RE: **Concord Meadows – Proposed Planned Unit Development 365 Concord Street
Notice of Intent Peer Review MassDEP File No. SE 273-0416**

The purpose of this letter is to address comments received from Mr. Jonathan Niro and Mr. Gary James, P.E. of BETA dated 8/30/21.

Comments from BETA, dated 8/30/21

BASIN 1

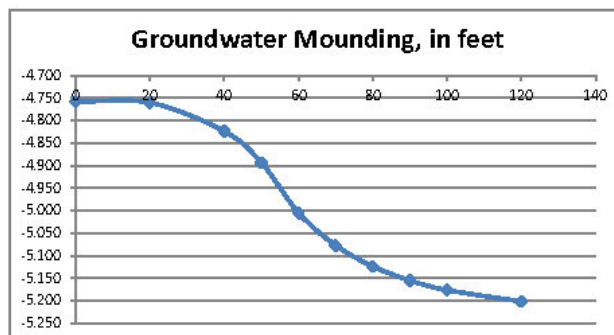
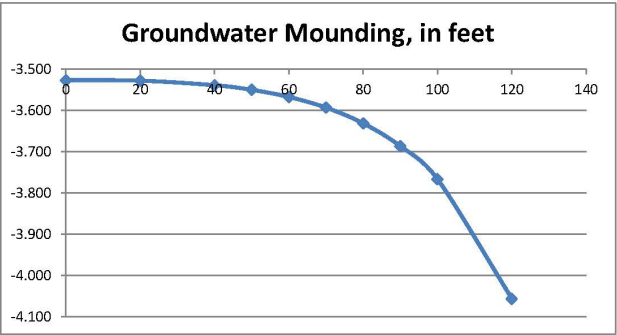
SW11. Provide data in the mounding analysis that documents the saturated thickness used in the analysis.

Response: Mounding analyses have been revised to use 12 hours plus the individual dewatering time for each infiltration basin. Mounding calculations for each basin are still less than 2'.

PROJECT NO. : 19.103	DRAWING NO.
SCALE : AS SHOWN	ECSA
DATE : 6/1/21	
DELINEATED BY : JZ	
DRAWN BY : DB/CR	SHEET NO. 1 OF 2
CHECKED BY : BPS	FILENAME: X:\PR\2011\19.103\DWG\2019\PRELIM 2/18/21

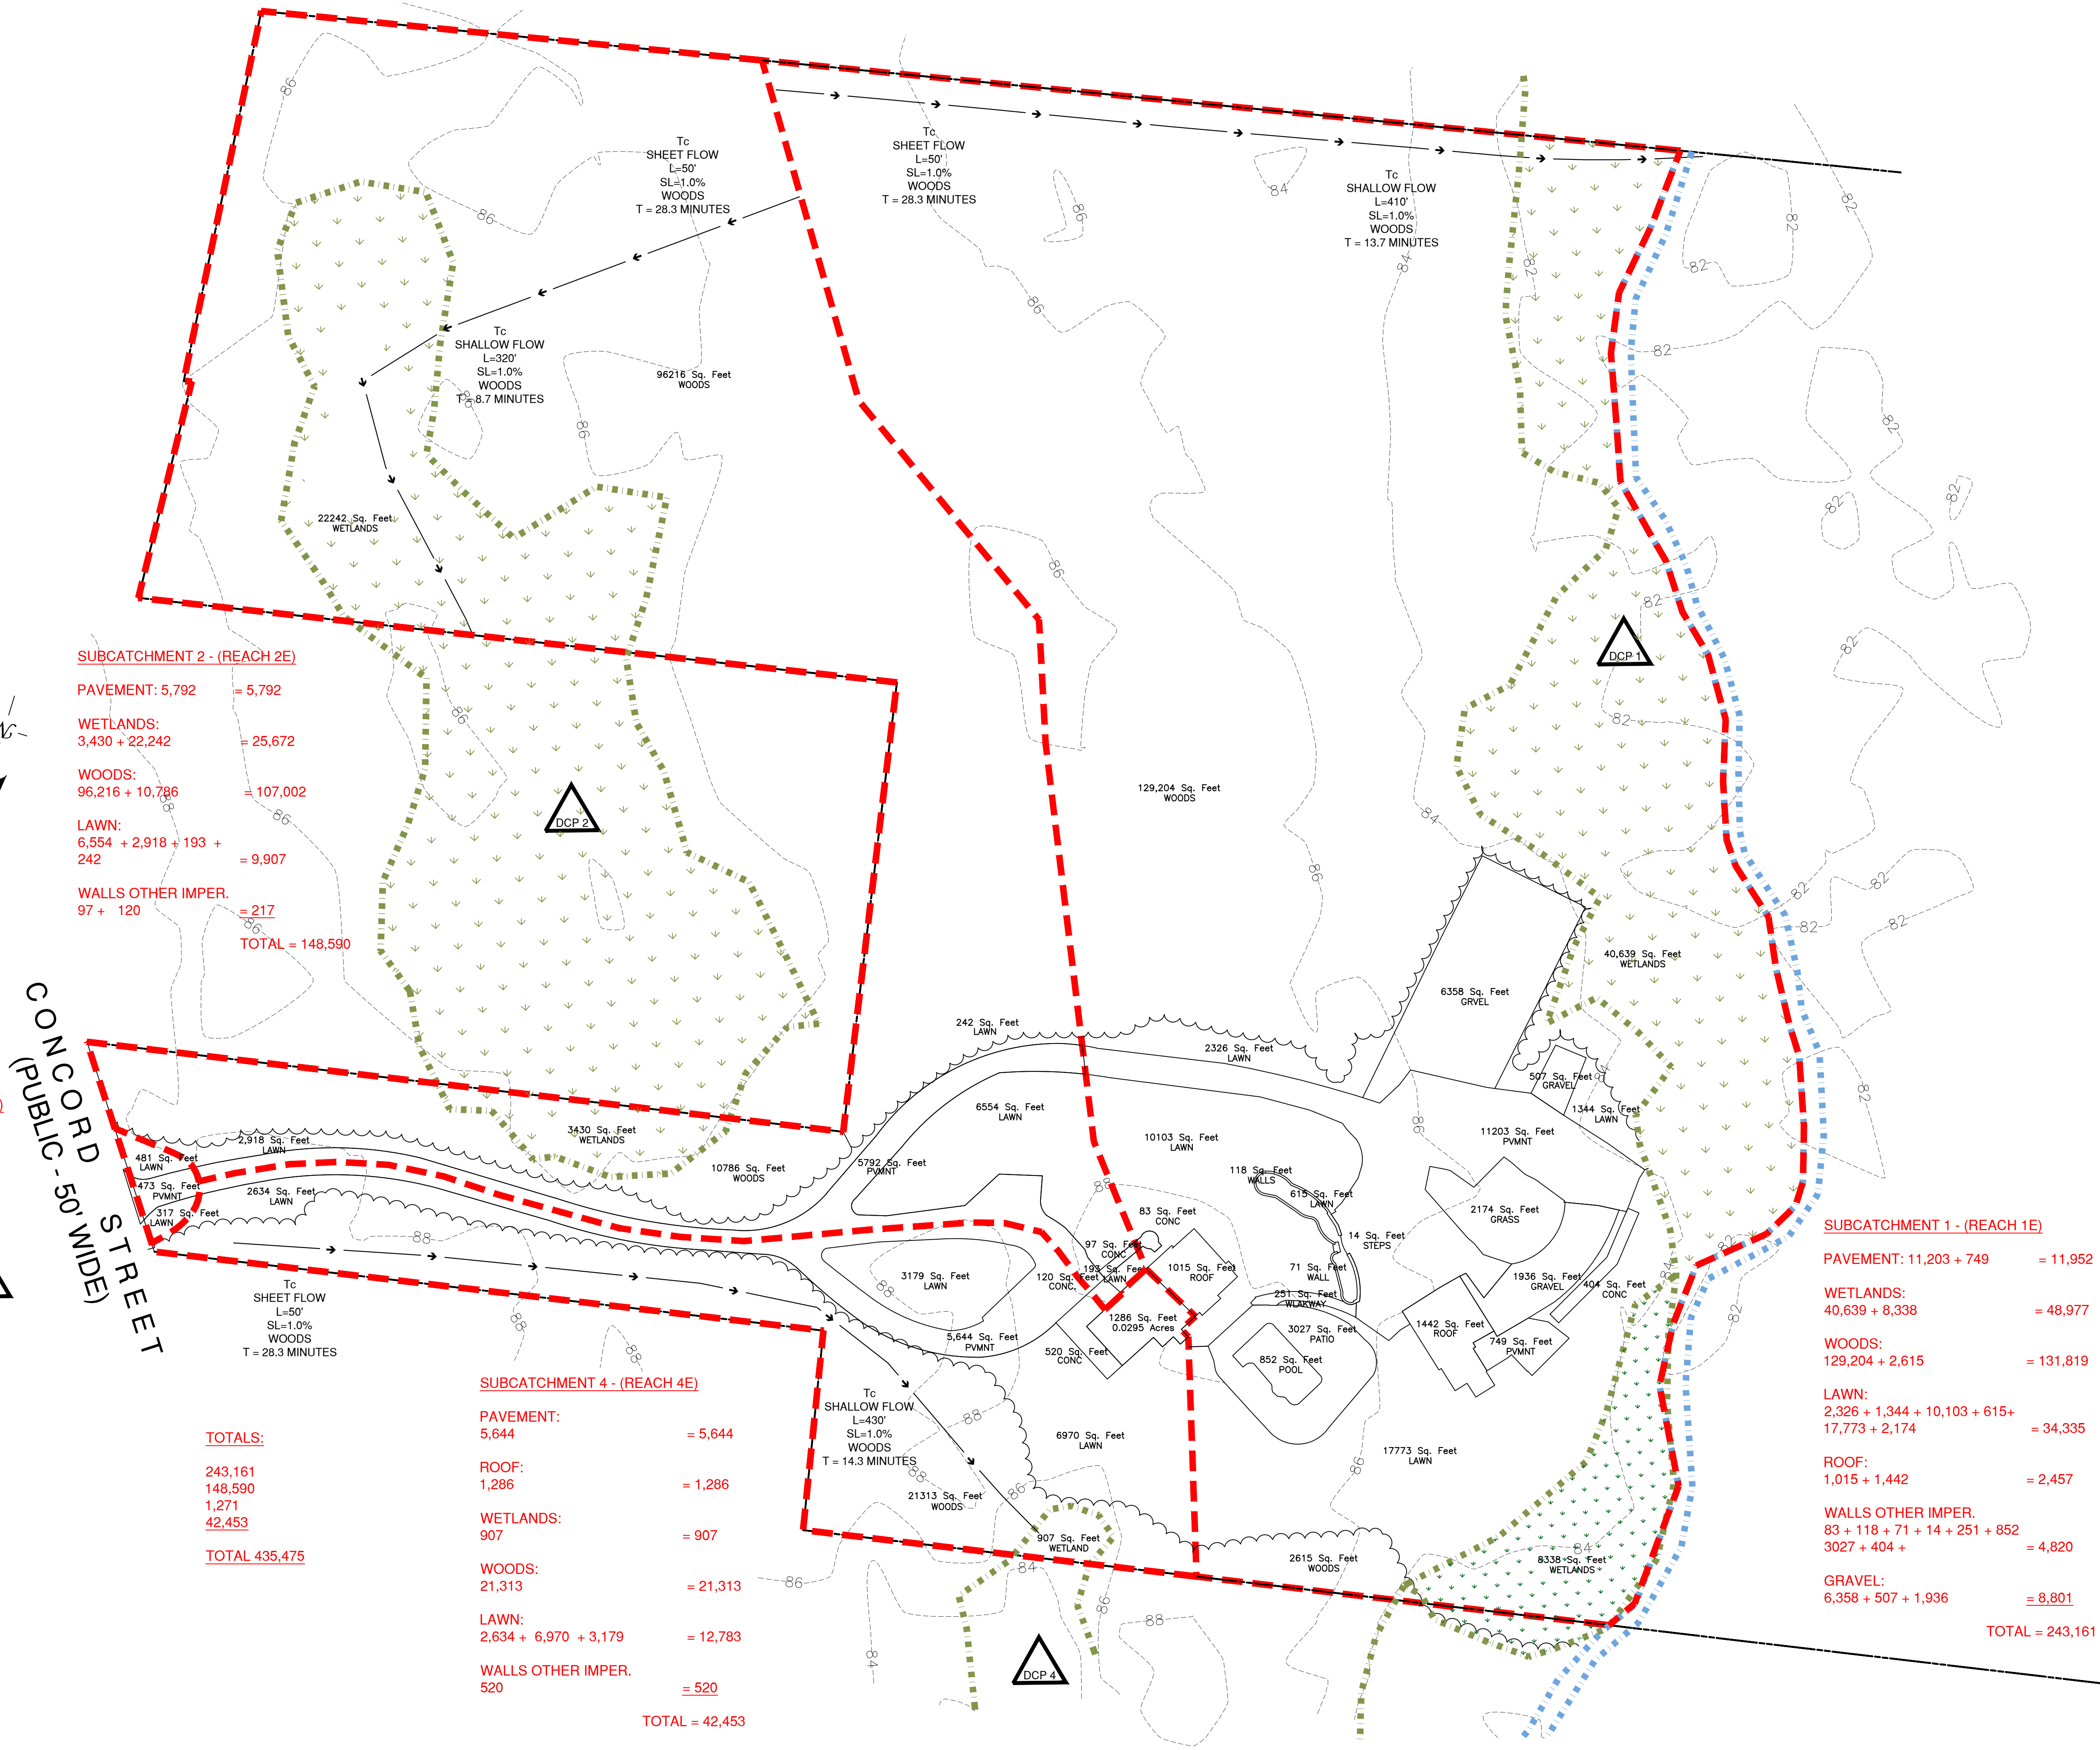
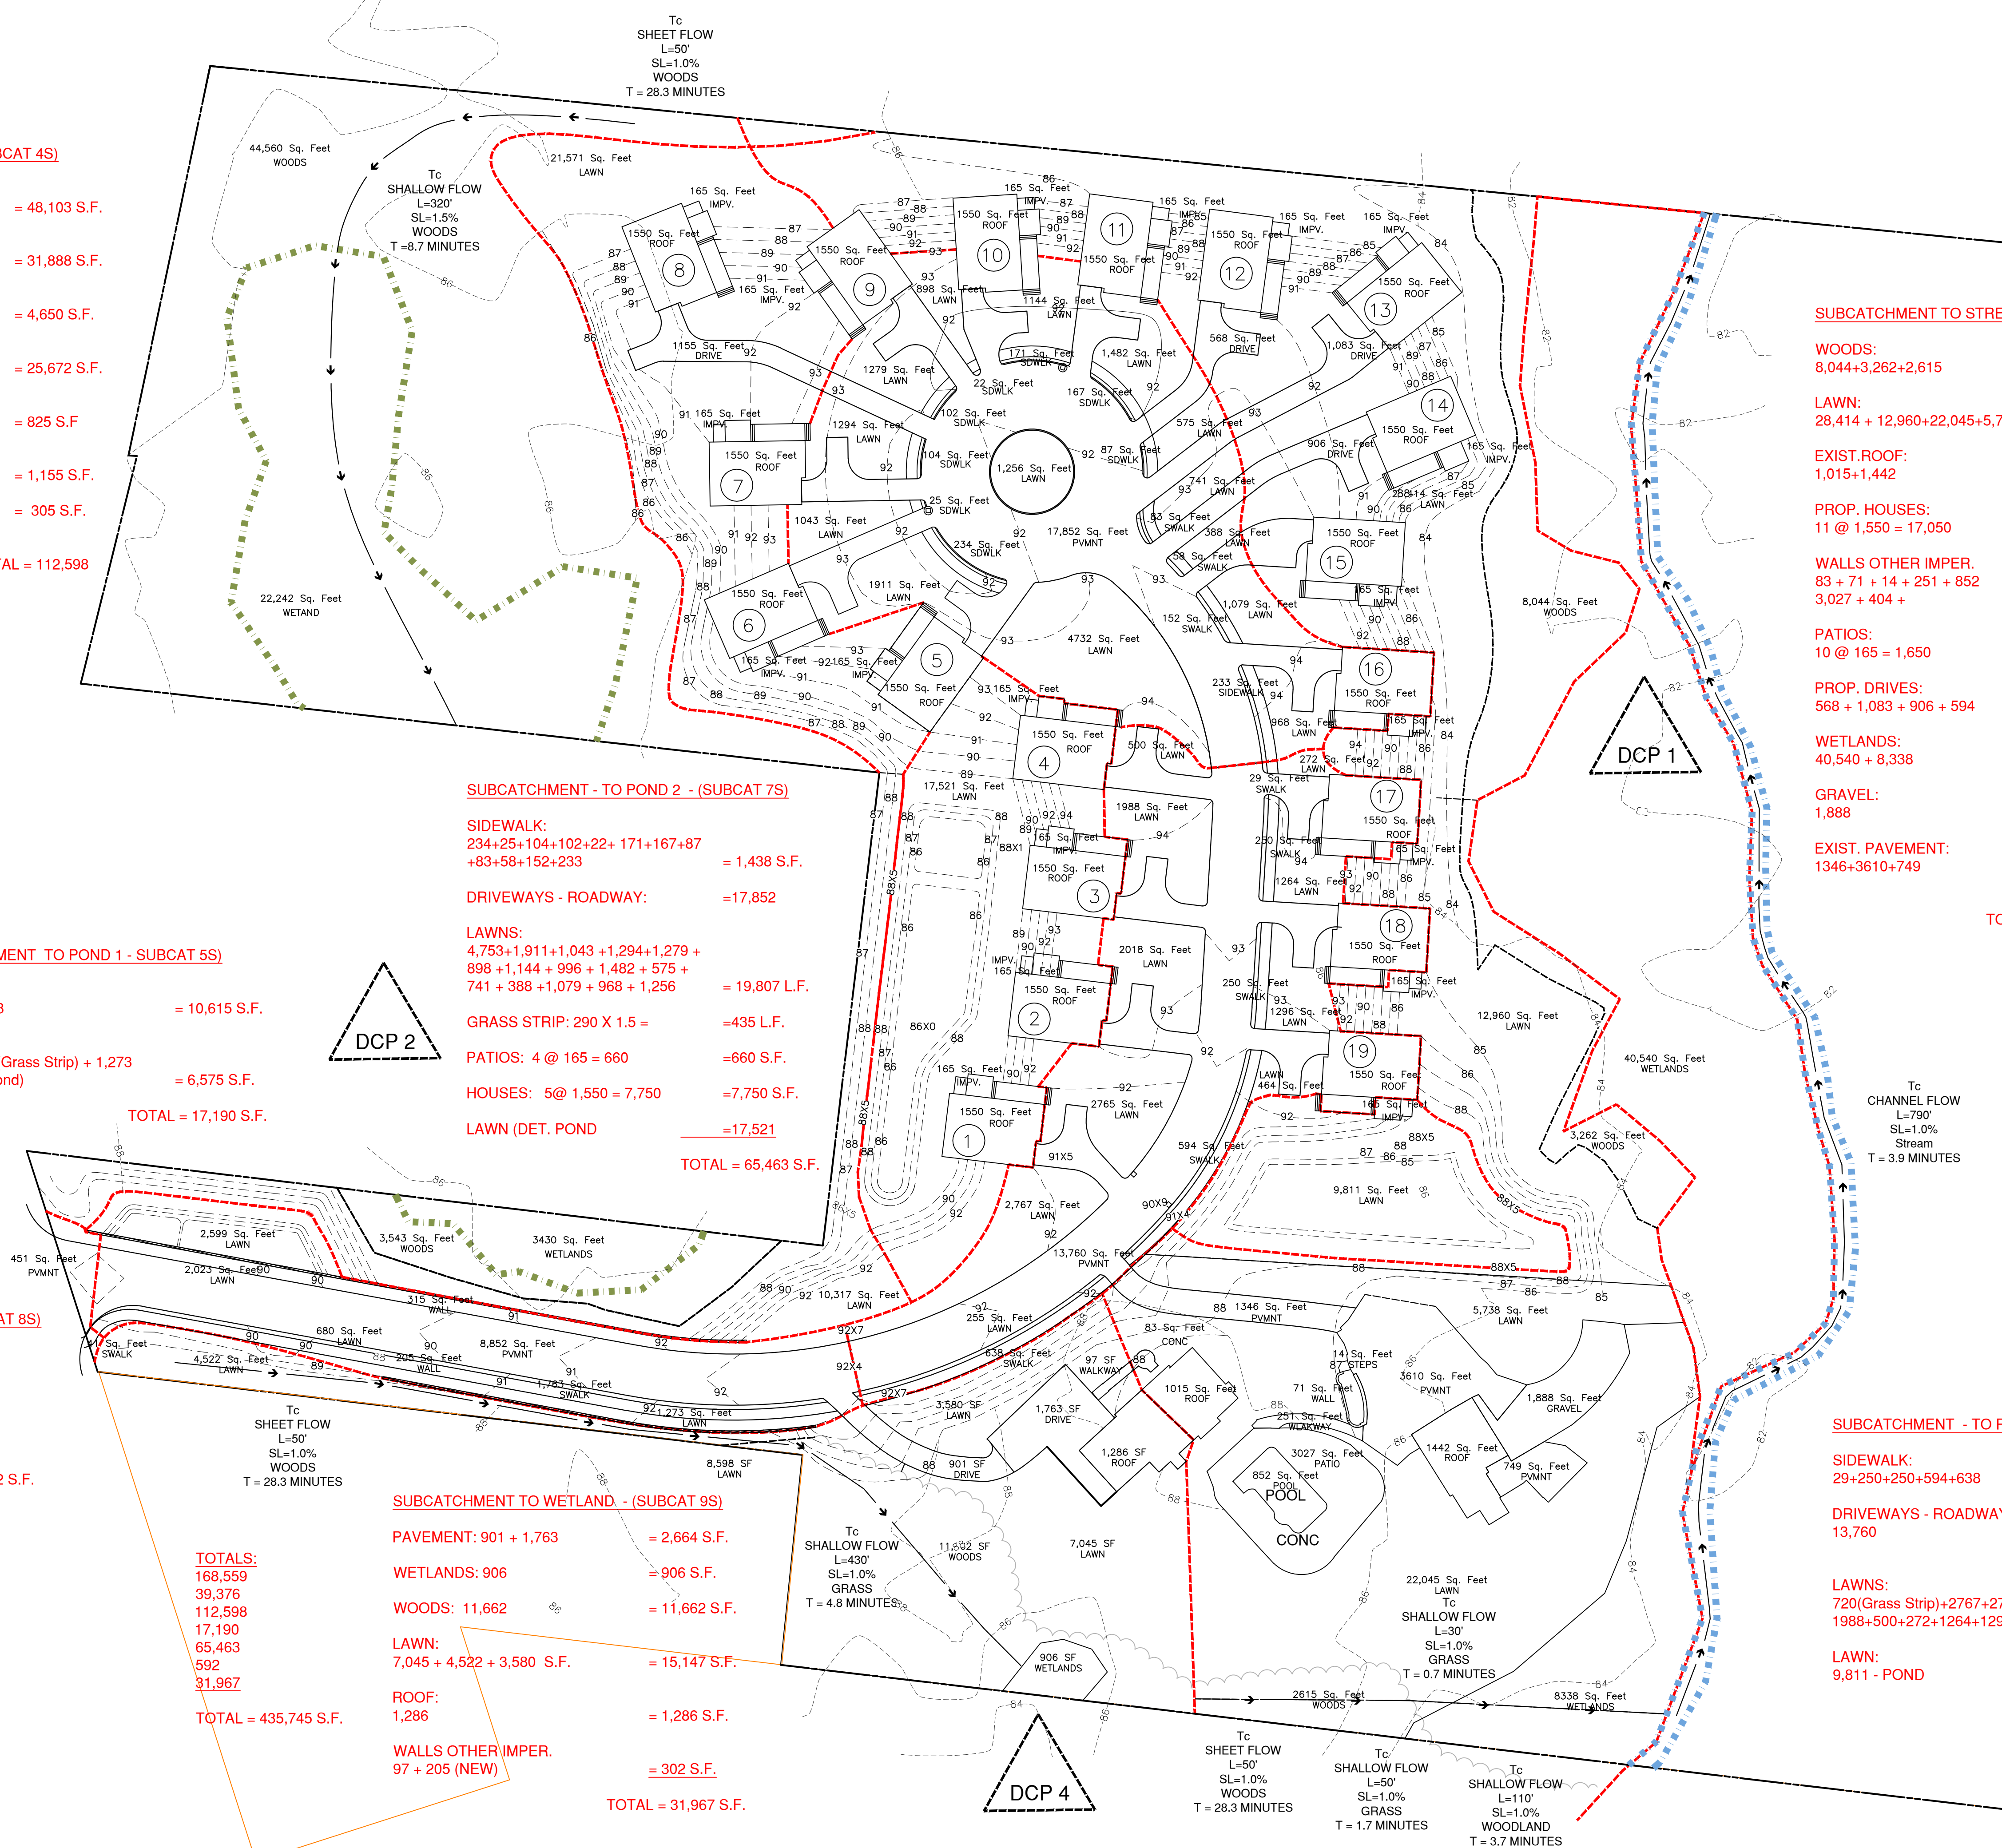
SW4. Update watershed maps to show both existing and proposed contours which will allow BETA to confirm an accurate watershed delineation.

Contours have been added to the watershed maps.
